**DEVIATION REQUEST
AND DECISION FORM**

Project Name : Latigo Filing 10
 Schedule No.(s) : 4200000352
 Legal Description : SEE ATTACHED – Exhibit C

A deviation from the standards of or in Section **ECM section 3.3.7 Permanent Storm Water Management Facilities** of the Engineering Criteria Manual (ECM) is requested for the proposed Temporary "Full Infiltration Treatment Control Pond".

PCD File No. SF-21-037

EXHIBIT A

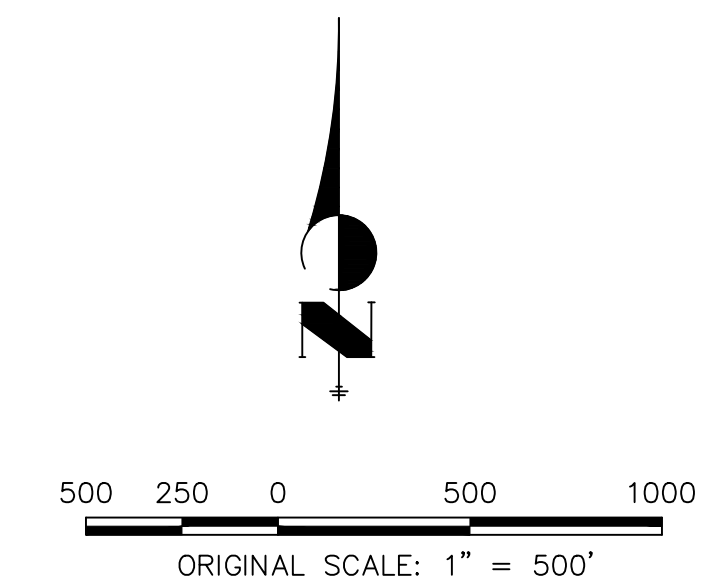
As stated in the **Final Drainage report** a Full Spectrum Extended Detention Basin is ultimately proposed to be located just off of Black Squirrel Creek and along Eastonville Road (see attached exhibit). This pond will ultimately provide detention for Filings 10, 11 and 13. The ecological study and permitting for this pond will be extensive due to the fact that the pond outfall will lie within identified wetland and mouse habitat. While this permitting is taking place the owner is requesting to provide an "interim" infiltration pond as discussed above in order to move forward with Filing 10.

Update paragraph to make it clear the "interim" infiltration pond will be removed and replaced by the ultimate pond (EDB) with Filing 11.
